JORGENSEN

OFFICE WAREHOUSE

GRADING/LANDSCAPE PLAN

GRADING and DRAINAGE PLAN
FOR LOT-8A
BLOCK-C UNIT-1 INTERSTATE
INDUSTRIAL TRACTS

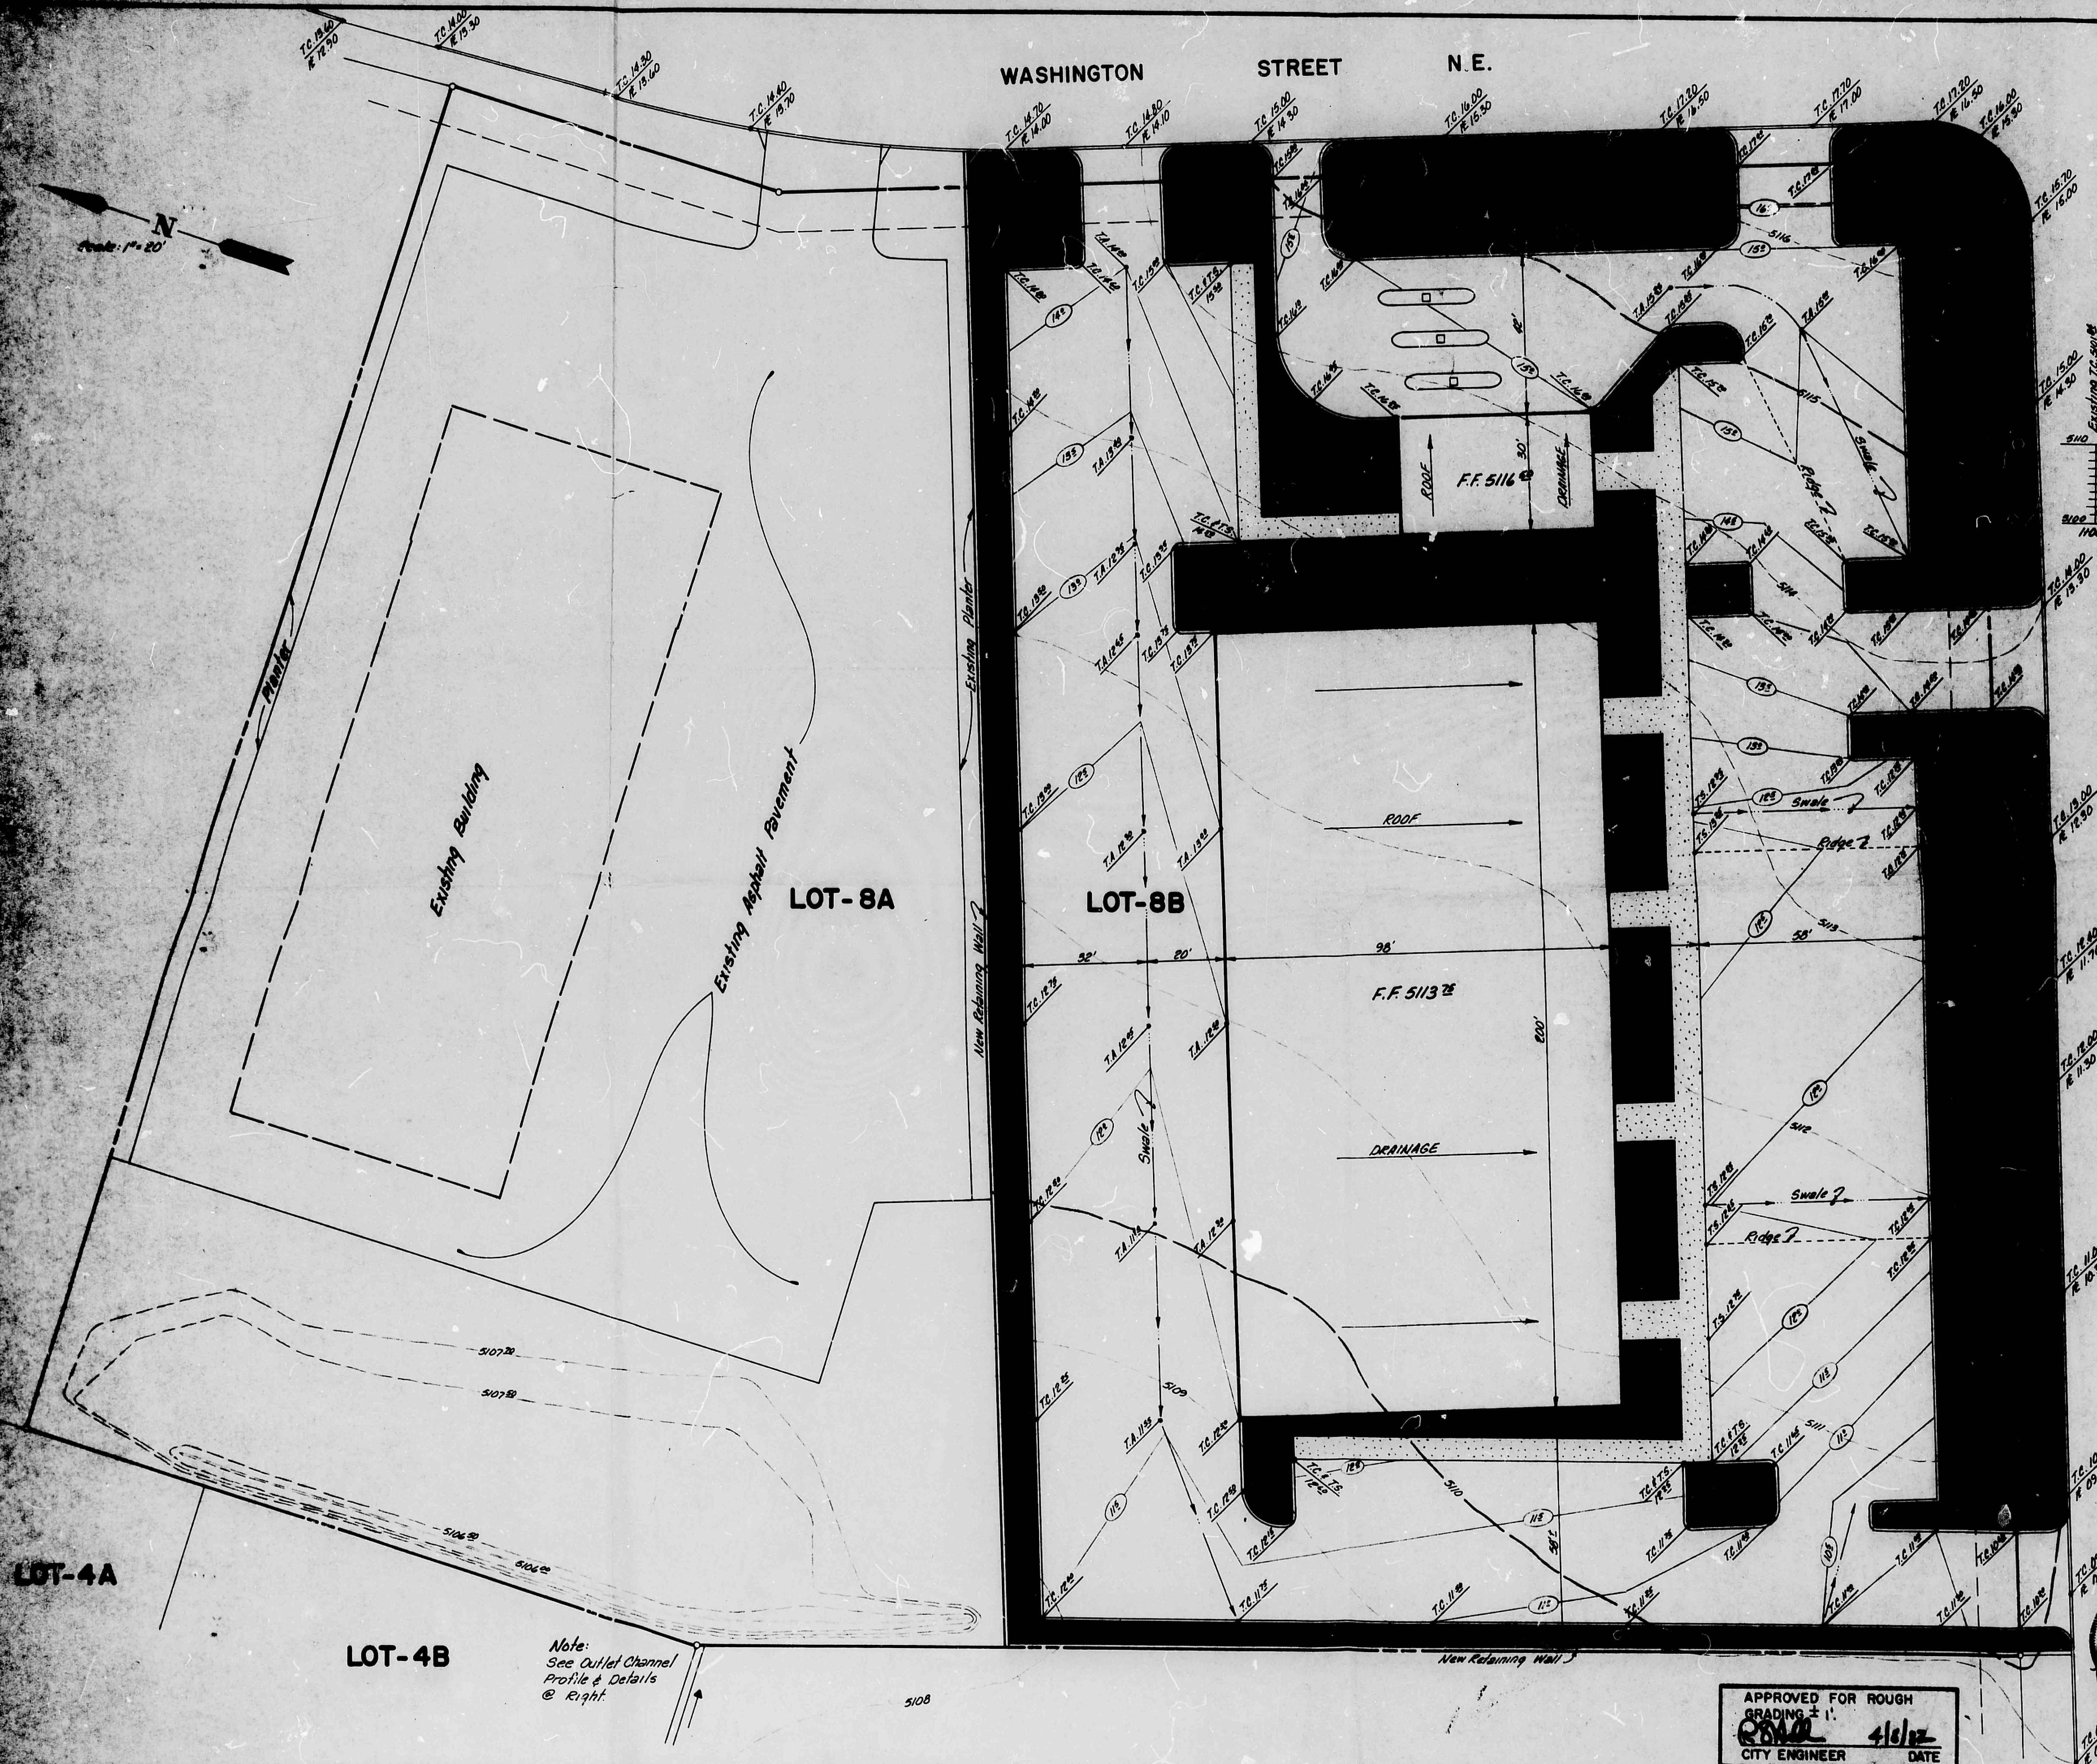
ASPHALT CURB SHOWN ON CONSTRUCTION DOCUMENTS SHALL BE DELETED, AS FIELD CONDITIONS DO NOT REQUIRE SUCH A WATER BLOCK
